## Executive Director's Recommendation

Commission Meeting: October 5, 2017

<b>PROJECT</b> <b>Dwight D. Eisenhower Memorial Modification</b> National Mall and Memorial Parks Bound by Independence Avenue, 4th, and 6th Streets, SW, and by the Lyndon B. Johnson – U.S. Department of Education Headquarters Building Washington, DC	<b>NCPC FILE NUMBER</b> 6694  <b>NCPC MAP FILE NUMBER</b> 1.71(73.10)44551  <b>APPLICANT'S REQUEST</b> Approval of revised preliminary and final site and building plans  <b>PROPOSED ACTION</b> Approve revised preliminary and final site and building plans  <b>ACTION ITEM TYPE</b> Staff Presentation
<b>SUBMITTED BY</b> United States Department of the Interior National Park Service on behalf of the Dwight D. Eisenhower Memorial Commission	
<b>REVIEW AUTHORITY</b> Commemorative Works per 40 U.S.C. § 8905

# NCPC File # 6694

PROPOSED ART FOR THE TAPESTRY WITH PANELS SHOWING MOCKUP LOCATION

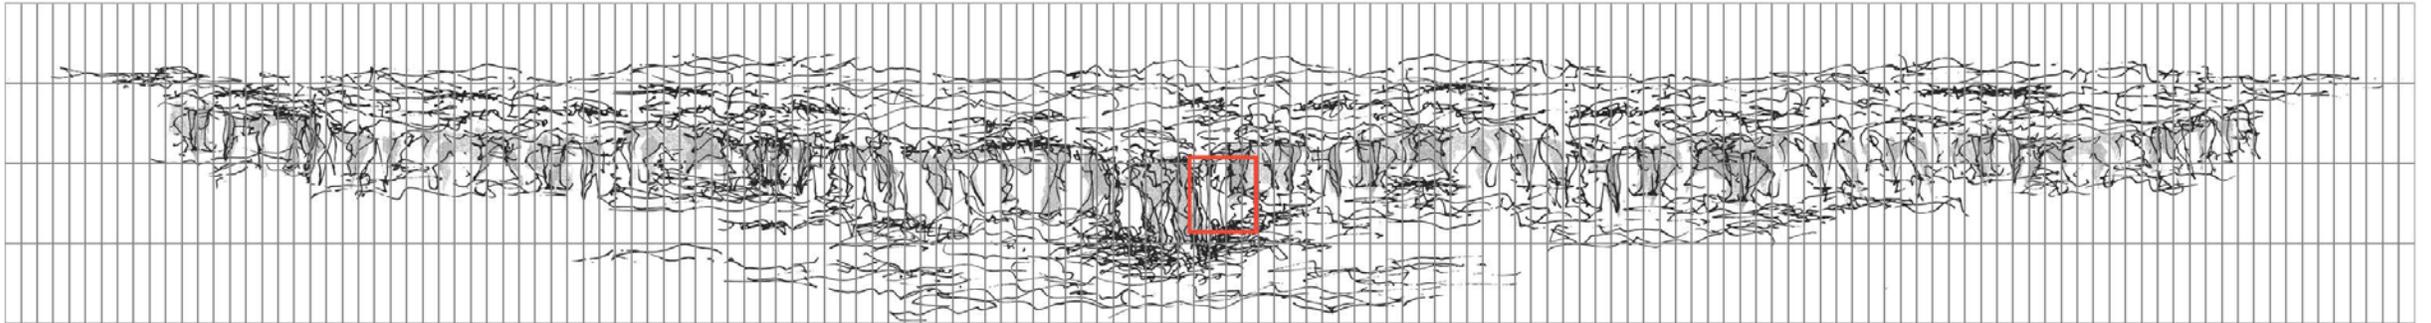
*Proportion:* The Commission questioned the ability to read and recognize the coastline of Normandy and distinguish between the water, land, and sky from the presentation materials. They noted that the majority of the coast falls within the lower part of the tapestry resulting in an image that is largely composed by clouds. They recommended raising the horizon line. They also noted that the image seemed forced and stretched to fit the 447-foot long canvas size, and recommended to further study the image proportion and composition in relationship to the size of the tapestry. In response to the Commission's comments, the image is now centered within the frame of the tapestry, and fits the tapestry proportionally, leaving blank spaces around the frame. The image now focusses on the landscape instead of the water and sky. The landscape fades away around the east, west and south edges of the tapestry.

Based on the analysis presented above, staff **notes that the applicant has modified the tapestry image to address the Commission's comments regarding level of transparency and the overall proportion of the image on the tapestry. The applicant provided additional visual studies and a mockup on-site as requested by the Commission. Staff also finds that the image preserves views to and from the Lyndon Baines Johnson Building U.S. Department of Education Headquarters.**

Looking South at Homecoming Inscription on Wall and Sculpture of Young Eisenhower

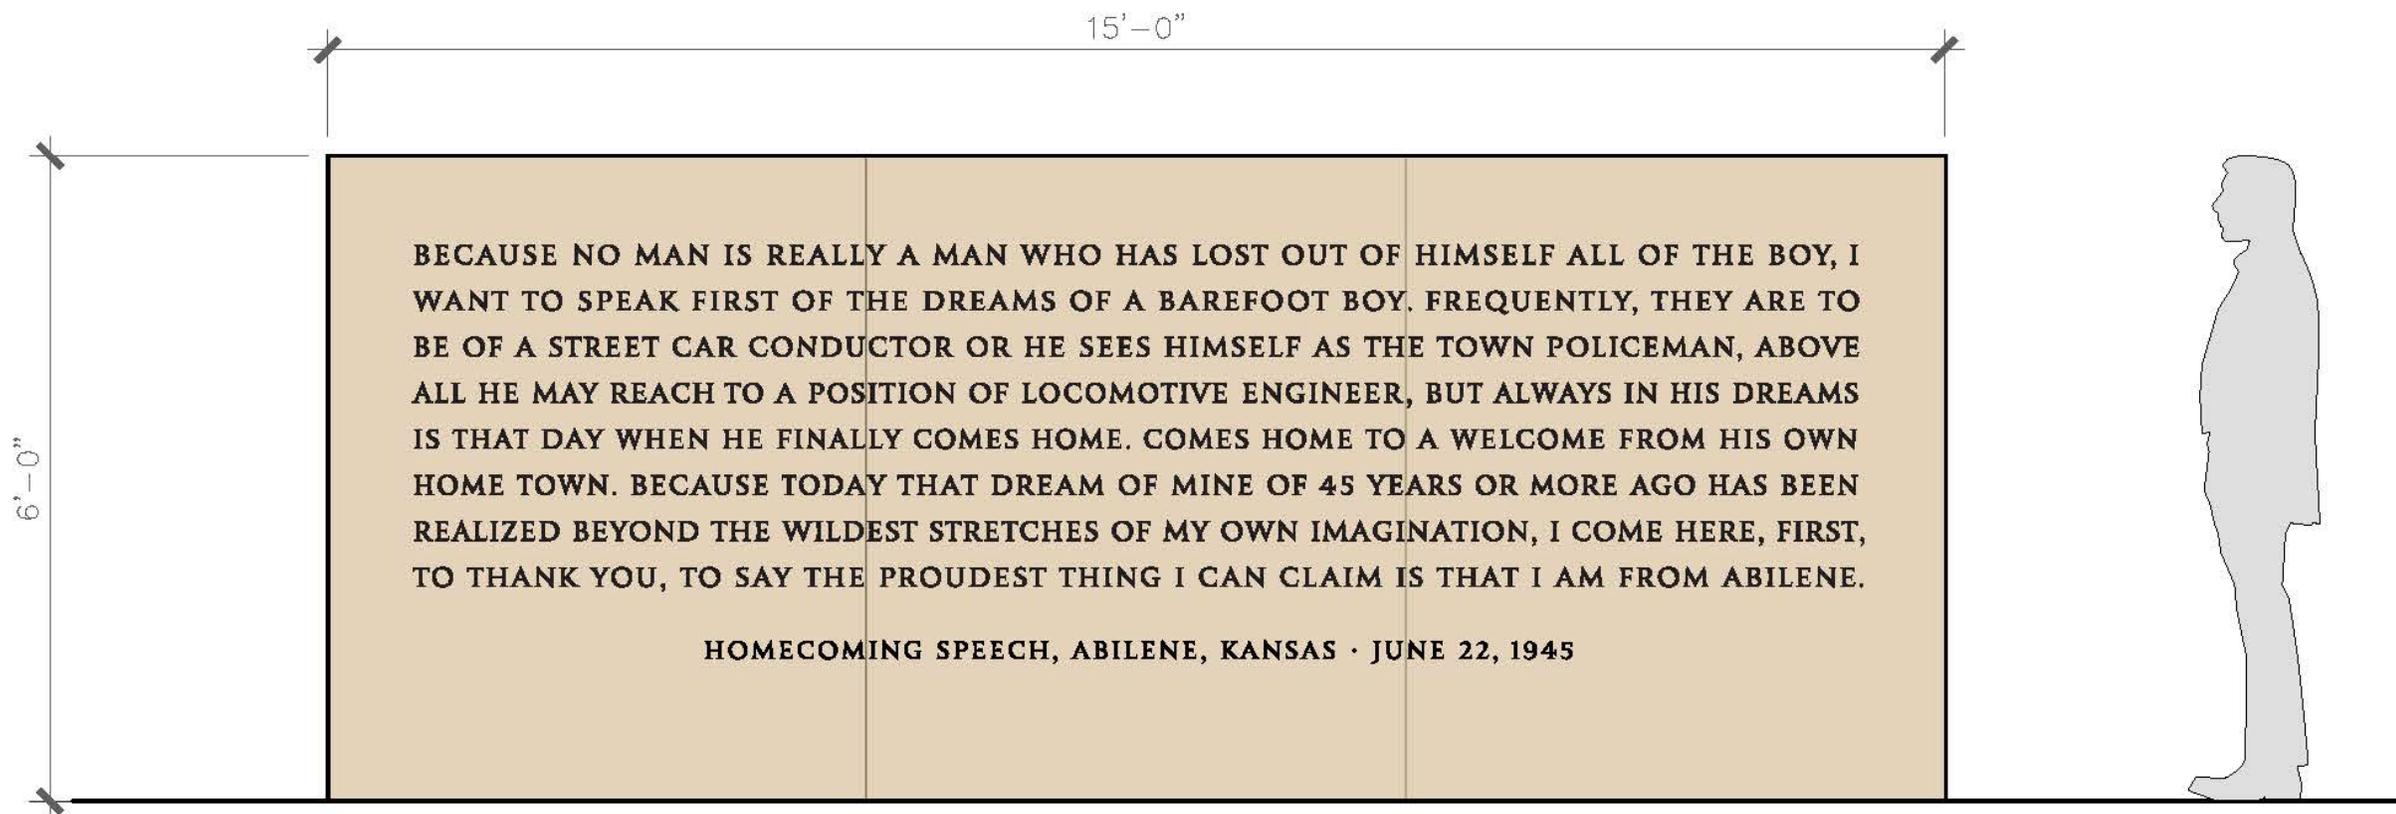
As mentioned in the previous Commission's comments section above, during the February 2017 concept review, the Commission expressed concerns about removing the young Eisenhower sculpture from the center of the memorial to a less visible and prominent location at the LBJ promenade, behind the tapestry. The design team has further refined the statue of Eisenhower as a young man in response to previous Commission comments.

The new six-foot tall by fifteen-foot long inscription wall plays an important role framing the southern edge of the plaza. The intermediate height of the wall reinforces the transition from human scale of the young Eisenhower sculpture to the larger memorial elements, such as the adjacent monumental column. Therefore, staff finds that the placement of the young Eisenhower sculpture and related inscription wall at the entry plaza on the northwest corner of the site complements the memorial elements and thematic organization; relates to the surrounding context; provides a relevant setting for this key memorial piece; and creates a sense of arrival.

**Staff notes that the young Eisenhower sculpture has been relocated from the Lyndon Baines Johnson (LBJ) Promenade, behind the tapestry, to the memorial foreground as requested by the Commission.**

CANOPY TREES ADDED BACK TO DESIGN

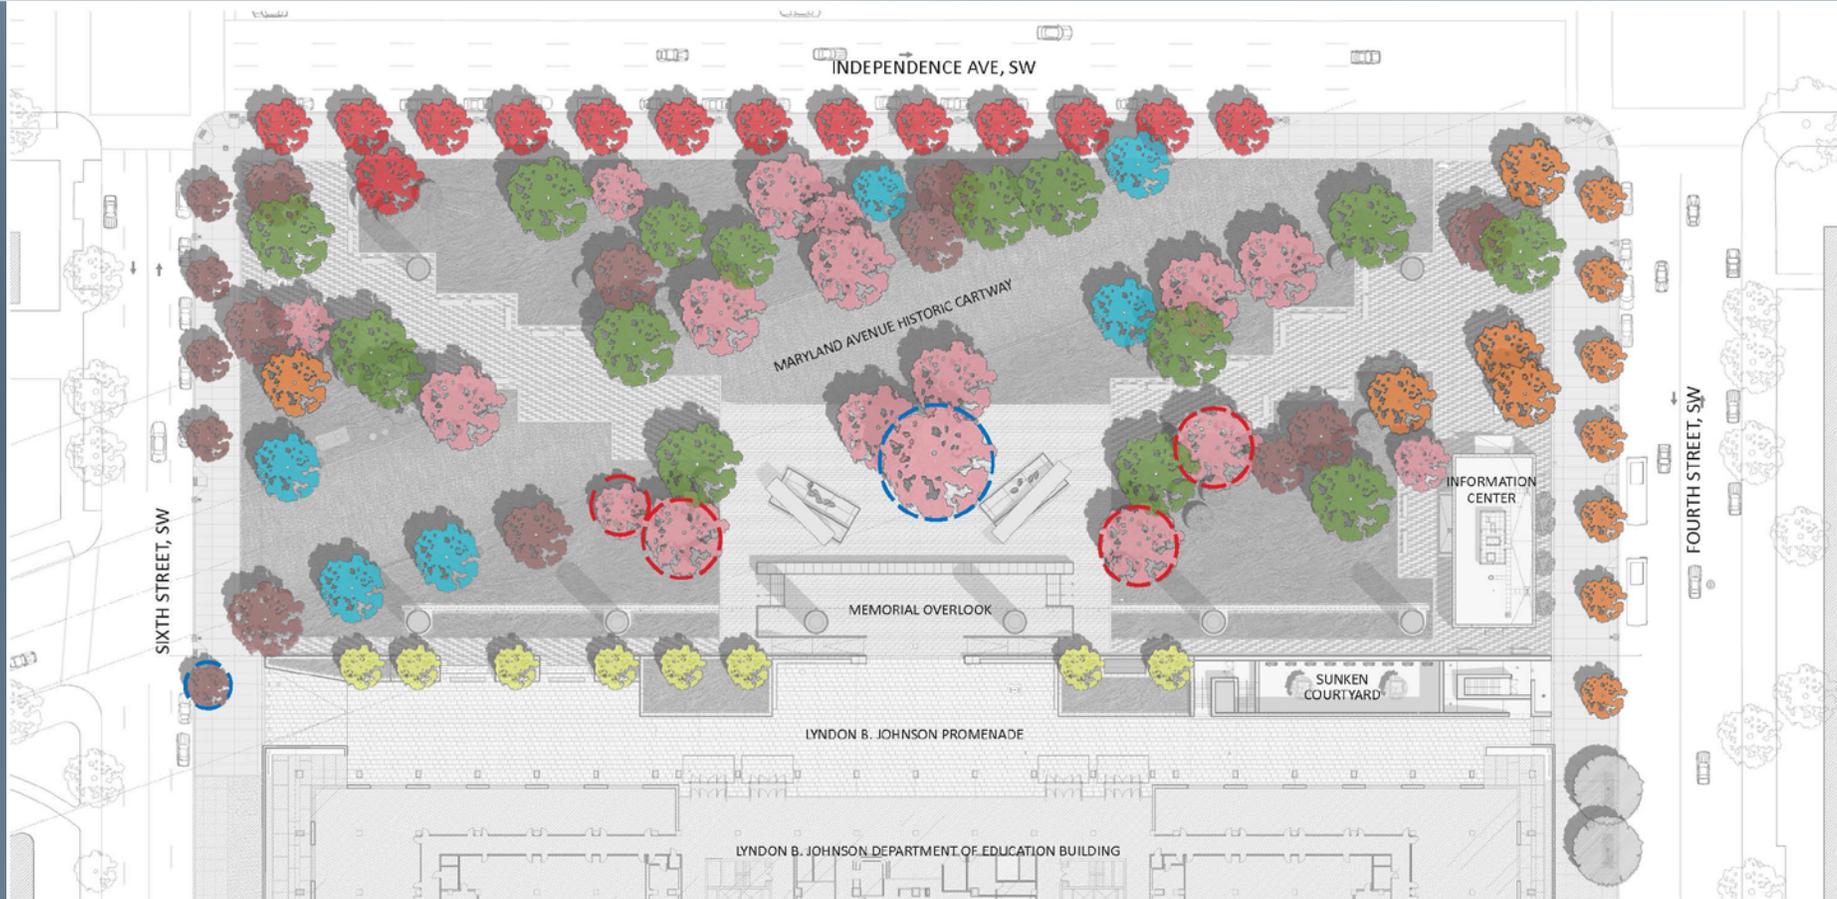
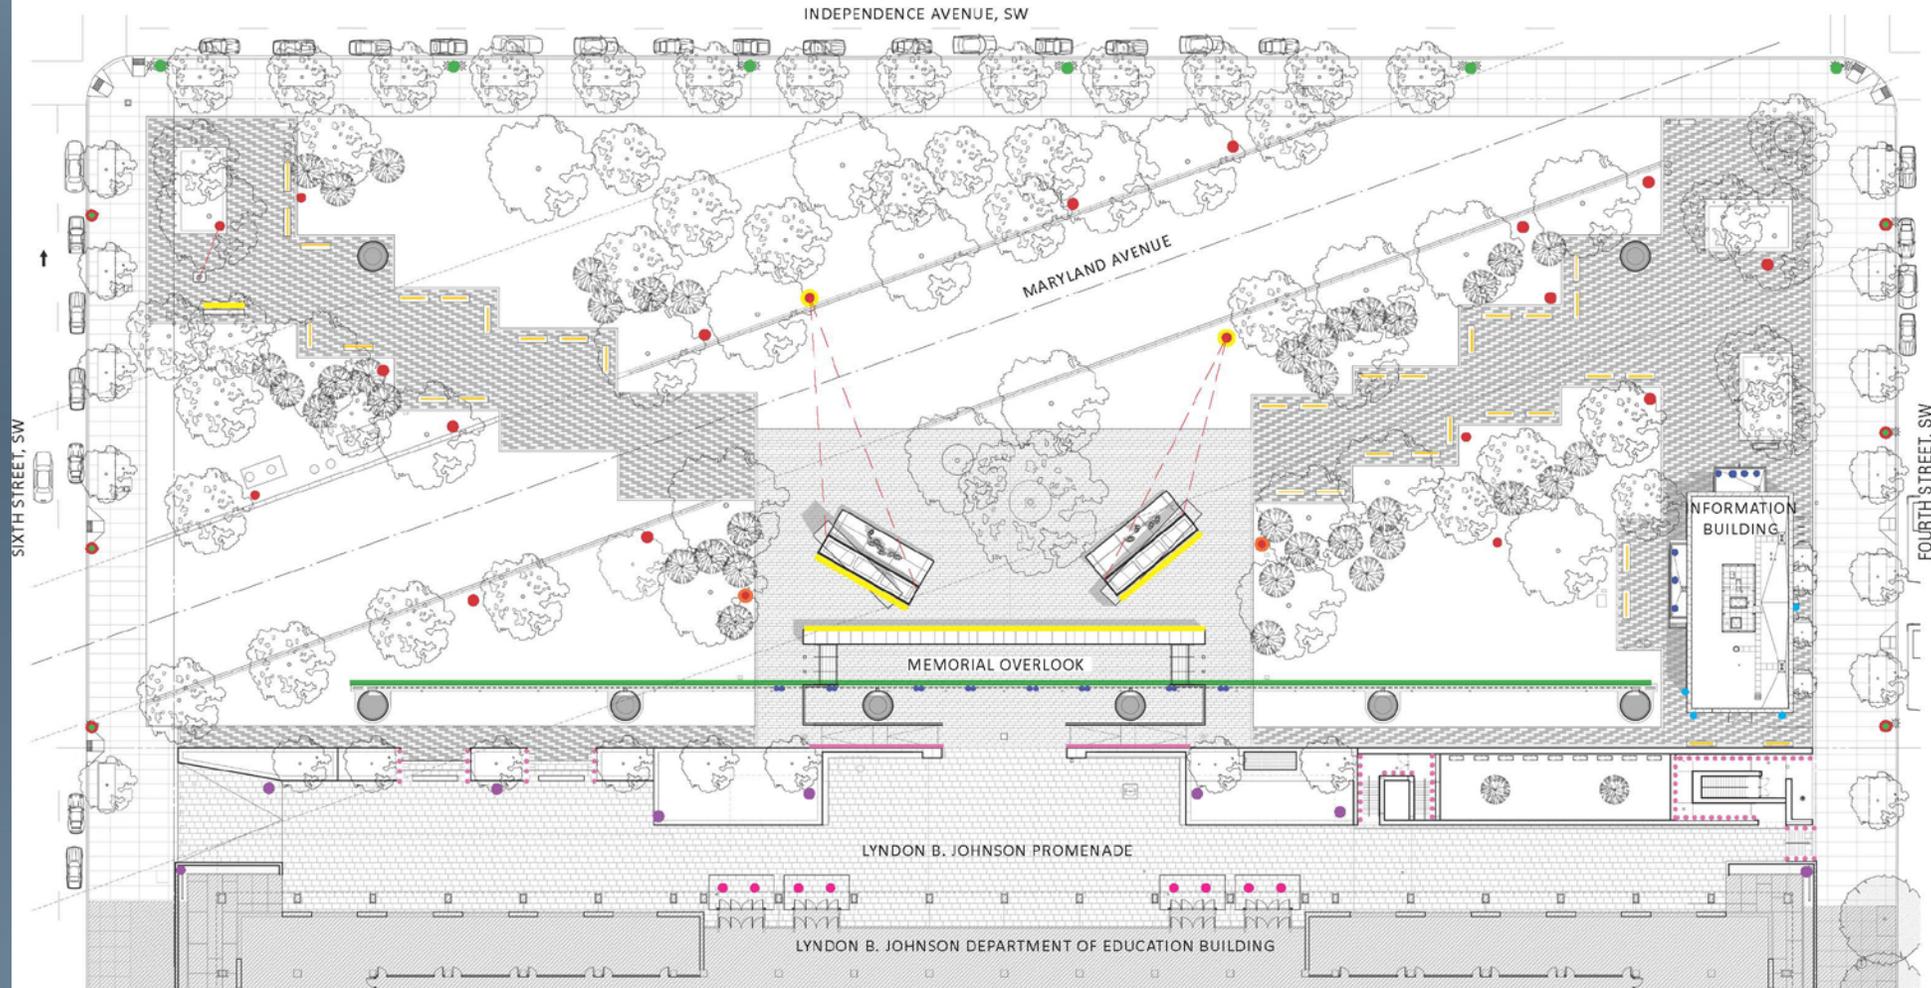
The landscape planting plan has returned to the previously approved 2015 design. In February 2017, the team proposed the removal of four trees adjacent to the Memorial core to increase views to the tapestry. The tree removal has been reconsidered, and is no longer being proposed. The current design proposes a species revision at the memorial core center tree from a London Plane to a Bur Oak to give the central grove of trees a stronger character and presence. Additionally, an existing street tree originally proposed to remain on Sixth Street, SW, is being replaced with a Swamp White Oak in the current design to match the other proposed street trees along the west edge of the memorial. The existing tree is being removed from the project due to the poor health.

In its January 23, 2017 meeting, CFA did not support the proposed removal of the four canopy trees from the design, commenting that this removal would reduce shade for visitors to the Memorial while not appreciably improving the perception of the tapestry. During the February 2017 concept review, NCPC staff noted in the staff report that the removal of four canopy trees would affect the urban tree canopy and shade along the proposed public space; however the impact would not be significant. In addition, staff found that the overall landscape design continued to respect the alignment of trees and frame the Maryland Avenue cartway, framing the Capitol vista. Maintaining the trees will contribute to this shaded oasis along Independence Avenue and improve the visitor experience. Therefore, staff **supports the retention of the four canopy trees previously considered for removal because they strengthen the notion of a memorial within a park, frame the Maryland Avenue viewshed and provide shade.**

Homecoming Speech inscription wall and the figure of Eisenhower as a young man looking south

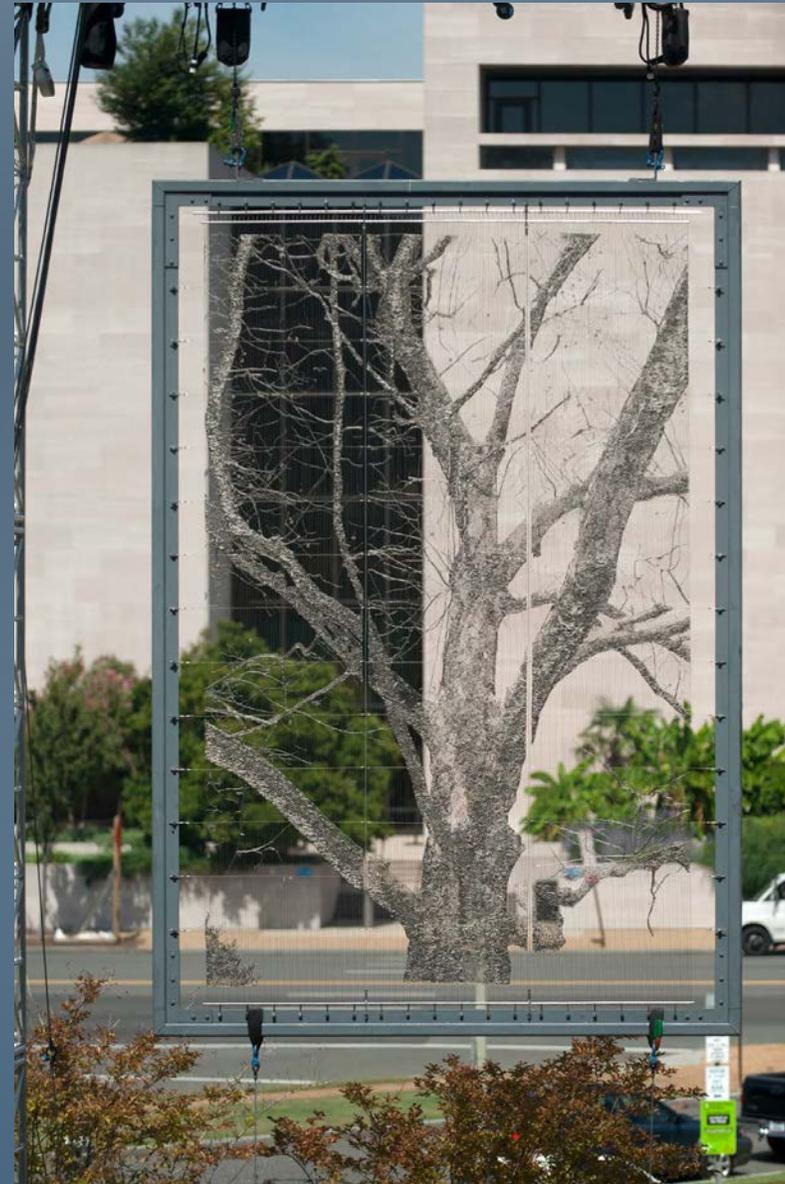
In February 2017, the Commission *requested a revised lighting plan consistent with the overall lighting design for the memorial that considers the relocated young Eisenhower sculpture and its associated inscription wall.* The lighting plan is the same as the previously approved design with the addition of lighting for the sculpture of Eisenhower as a young man and the new inscription wall at the Northwest Entry Plaza. The applicant has provided updated lighting plans, a perspective night view of the memorial core, and a rendering of the Homecoming Speech Inscription Wall and the figure of Eisenhower as a young man looking south.

The applicant proposes to illuminate the sculpture of Eisenhower as a youth with a single projector designed to focus on the statue. The Homecoming Speech inscription wall will have linear uplighting at the base of the wall similar to the Memorial core inscription walls.

Diagram of south tapestry showing estimated image densities (in percent solid) / September 2017 - Revised Preliminary and Final site and building plans

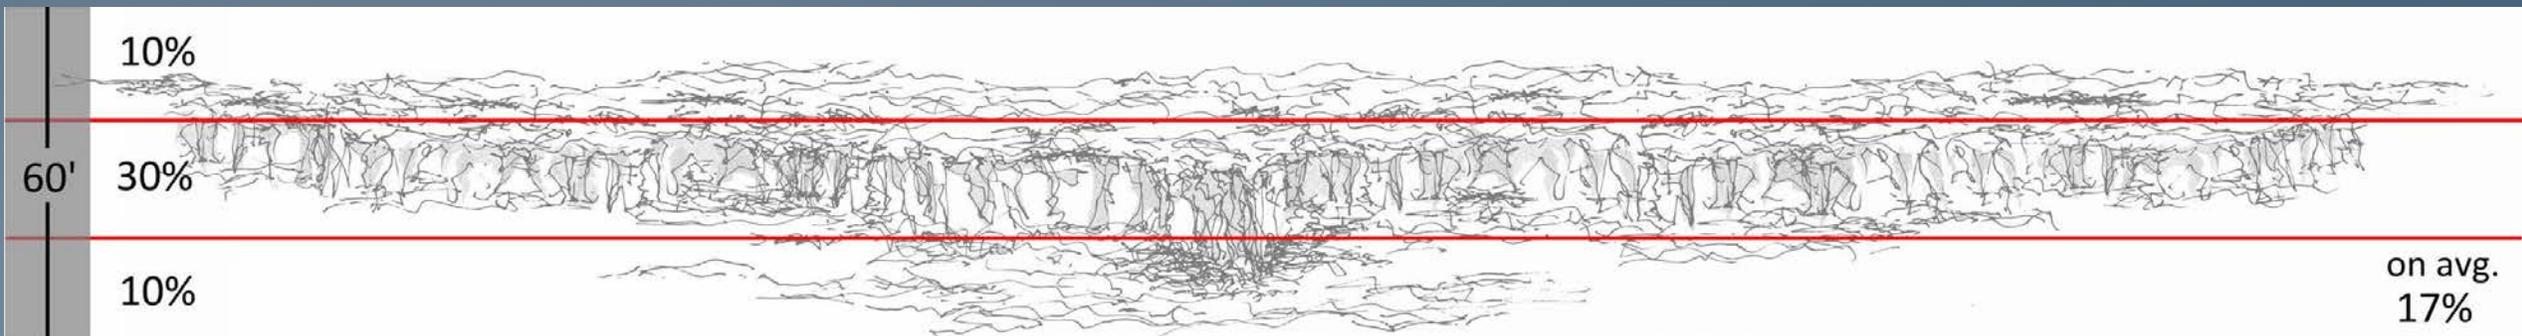
*Transparency:* Early in the design process, the design team established maximum opacity levels for engineering purposes for the 2011 tapestry mockup of the Kansas Landscape. These conservative values were developed for a wind tunnel test for the structural design of the cable net and columns, with the expectation that the real density levels would be less than these maximum values. The 60-foot tall tapestry was divided into three approximately equal horizontal sections. The opacity on the tapestry ranged from approximately 95 percent solid along the bottom of the image, transitioning to about 50 percent open in the middle and at the top about 20 percent opaque. The February 2017 revised tapestry with the Normandy image followed similar transparency levels. According to the estimated densities diagram, the transparency levels of the tapestry were maintained from the previous Kansas Landscape to ensure views to the LBJ Building and retain the building's identity. In general, both tapestries were more transparent towards the sky and denser at the bottom.

The current tapestry image has a graphic linework with some shaded accents on the vertical face of the cliffs and is more open and transparent. The applicant has indicated that 20 percent of the panels will be blank, without any linework other than the base structural grid of the panel, which will be 100 percent transparent. This is due to the elimination of the sky, and the way the cliffs and water fade on the edges of the tapestry, providing a floating effect. The design team has provided an opacity level diagram for comparison purposes, showing a similar conservative approach from the original tapestry design. The diagram shows that the 60-foot tall tapestry is divided into three approximately equal sections. The maximum opacity levels range from 10 percent opaque at the bottom to 30 percent opaque in the middle and 10 percent opaque at the top. Overall, the tapestry has equal transparency levels at the upper and lower sections, and is denser in the middle.

- The top section of the previous image provided the greatest transparency levels, with 20 percent opaque. The top section of the current image provides 10 percent opacity. The top portion of the current image is more transparent.
- The middle section of the previous image was 50 percent opaque. The middle section of the current tapestry, which represents the densest area of the image, is now 30 percent opaque. The middle section of the current image is more transparent.
- The lower section of the previous image provided the least level of transparency with 95 percent opacity. The lower section of the current image is now 10 percent opaque, which significantly improves transparency levels. The top and bottom portions are now more transparent.

As shown in the opacity diagrams shown in page 22 in the attached powerpoint, overall, the revised tapestry will be more transparent than the previous Kansas landscape and will not block reciprocal views to and from the LBJ building. The simplification of the linework and the lack of sky and clouds contributes to the transparency levels.
